CONSTRUCTION SUMMARY

7N - 3 - The Barossa 17 (S38-17) Elev B

Extras at Time of Sale

BAROSSA-17 *Lot 7*

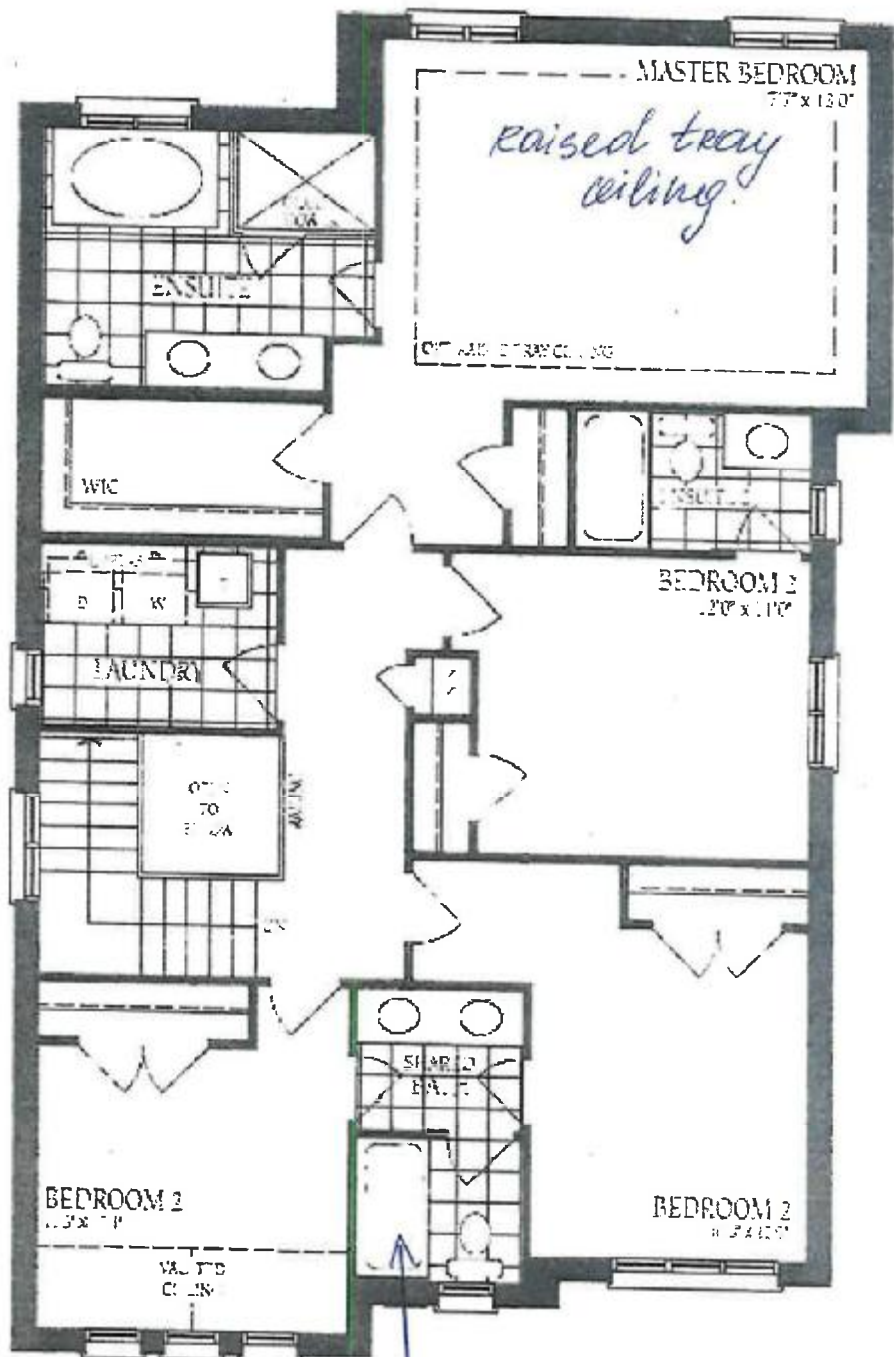
Inv.425	1 - MOVE EXISTING/KITCHEN WALL AND EXISTING KITCHEN CABINETRY WITH FRIDGE - 2FT TOWARDS DIDNING ROOM - AS PER SKETCH # 1 CENTER EXISTING DINING ROOM WINDOW - AS PER SKETCH # 2
Line3793	Note:
11Jul21 / 13Sep21

Inv.425	1 - ELECTRICAL - POT LIGHT - 1ST FLOOR NON INSULATED CEILING - PER POT LIGHT - DINING ROOM - AS PER SKETCH
Line3359	Note:
11Jul21 / 13Sep21	
Inv.425	8 - ELECTRICAL - POT LIGHT - 1ST FLOOR NON INSULATED CEILING - PER POT LIGHTS - GREAT ROOM - CENTERED IN SQUARES
Line3360	Note:
11Jul21 / 13Sep21	
Inv.425	1 - ELECTRICAL - EXTRA INTERIOR CEILING OUTLET ROUGH-IN - NO FIXTURE - ON NEW SWITCH - CENTERED KITCHEN AND BREAKFAST AREA - CENTERED
Line3728	Note:
11Jul21 / 13Sep21

Barossa - 17
WOB condition

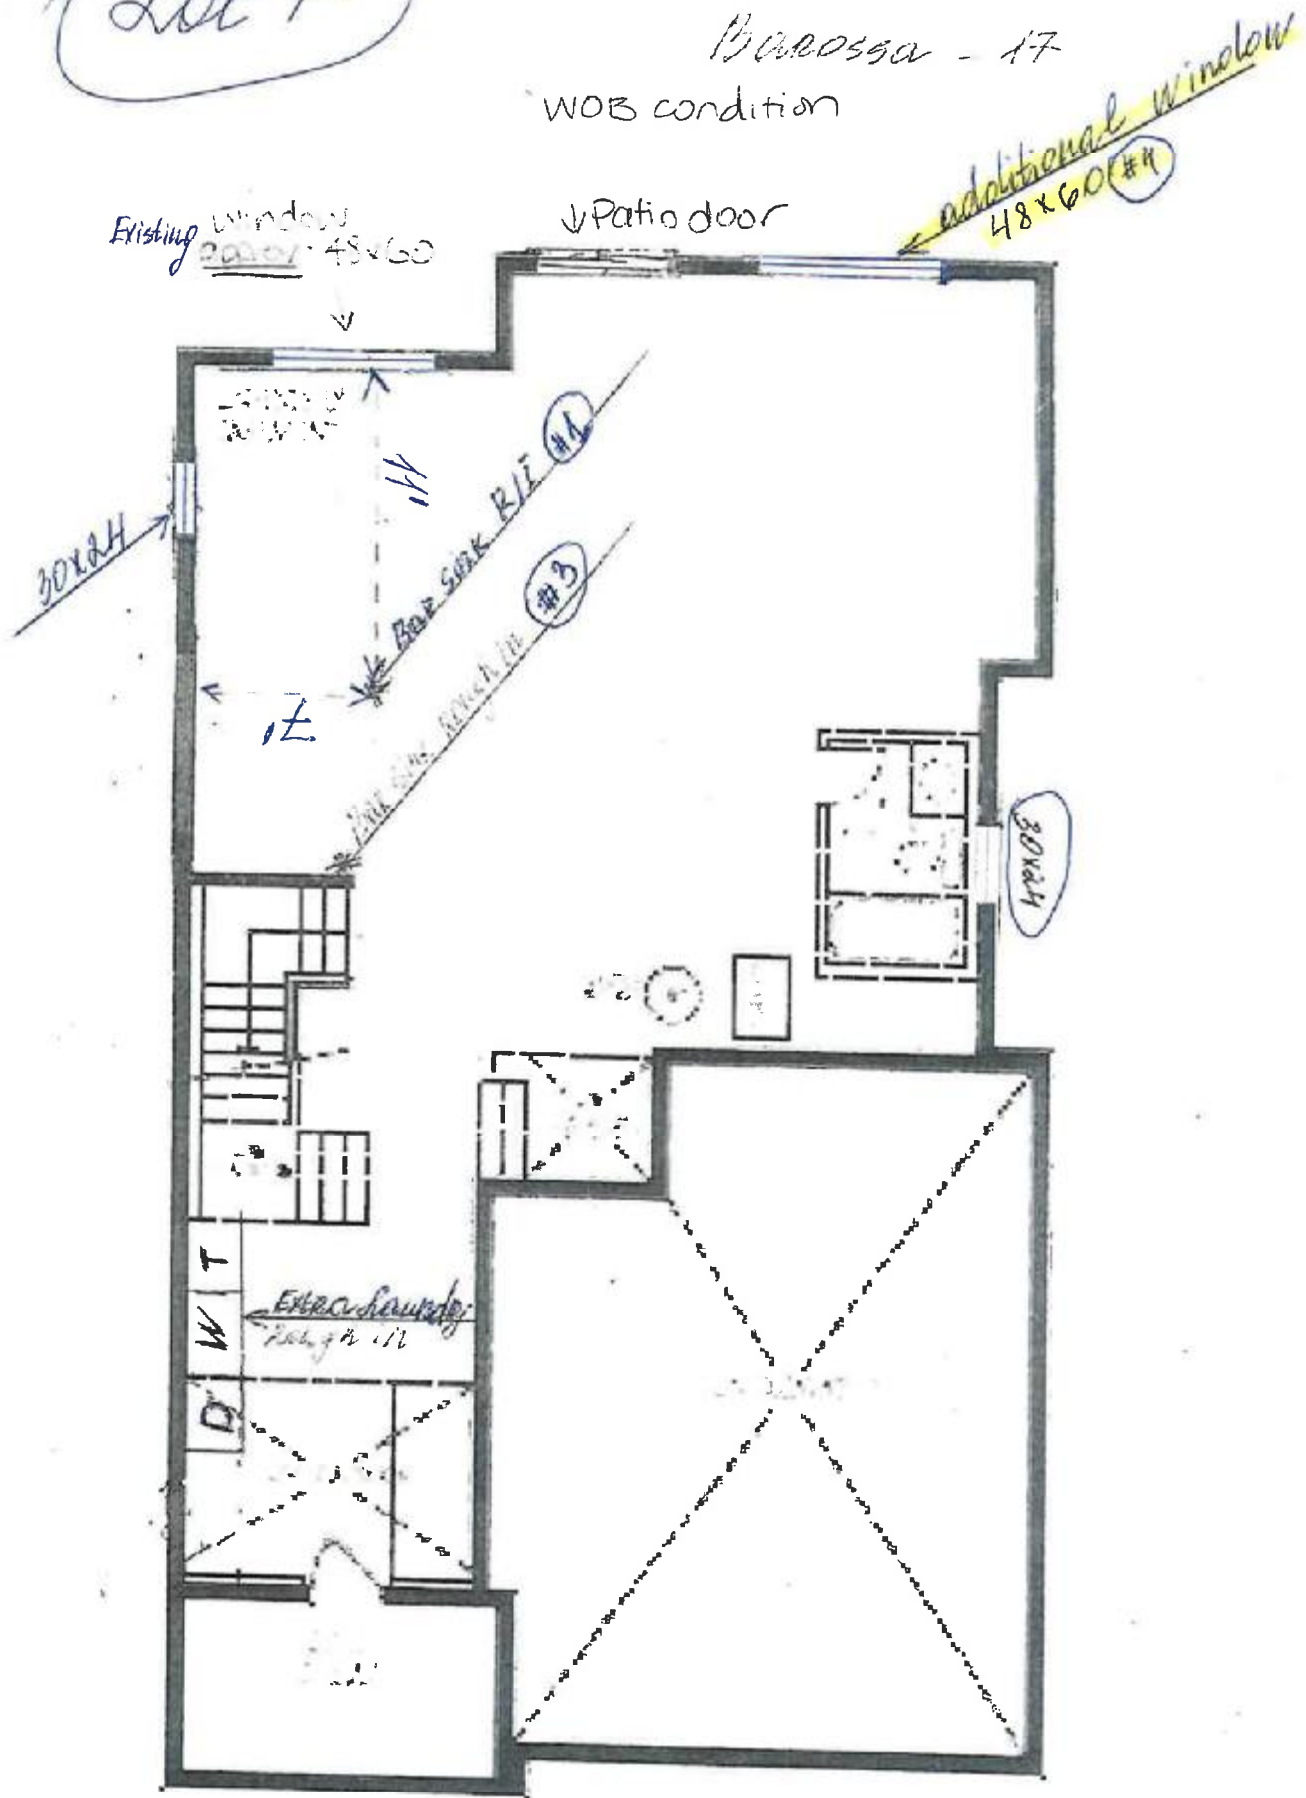
Inv.425	1 - PLUMBING - BAR SINK ROUGH IN ONLY - IN BASEMENT - AS - PER SKETCH - # 3
Line3350	Note:
11Jul21 / 13Sep21	
Inv.425	1 - PLUMBING - BAR SINK ROUGH IN ONLY - AS PER SKETCH # 1 - PLEASE SEE MEASUREMENTS ON SKETCH (7' FROM SIDE WALL AND 11' FROM REAR WALL)
Line3729	Note:
11Jul21 / 13Sep21	
Inv.425	1 - PLUMBING - ROUGH IN EXTRA LAUNDRY INCLUDES WASTE VENTS AND WATER LINES
Line3354	Note: IN BASEMENT - AS PER SKETCH
11Jul21 / 13Sep21	
Inv.425	1 - PLUMBING - BAR SINK ROUGH IN ONLY - AS PER SKETCH - DINING ROOM
Line3852	Note:
11Jul21 / 13Sep21	
Inv.425	1 - PLUMBING - BAR SINK ROUGH IN ONLY - IN KITCHEN AS PER SKETCH - 7,5 FT FROM EXTERIOR SIDE WALL AND 7,5 FT FROM REAR WALL - PLEASE SEE SKETCH
Line3853	Note:
11Jul21 / 13Sep21

Inv.425	1 - ADDITIONAL BASEMENT WINDOW - 48 X 60 AS PER SKETCH # 4
Line3796	Note:
11Jul21 / 13Sep21	
Inv.425	2 - BASEMENT WINDOW - 30 X 24 - AS PER SKETCH
Line3351	Note:
11Jul21 / 13Sep21
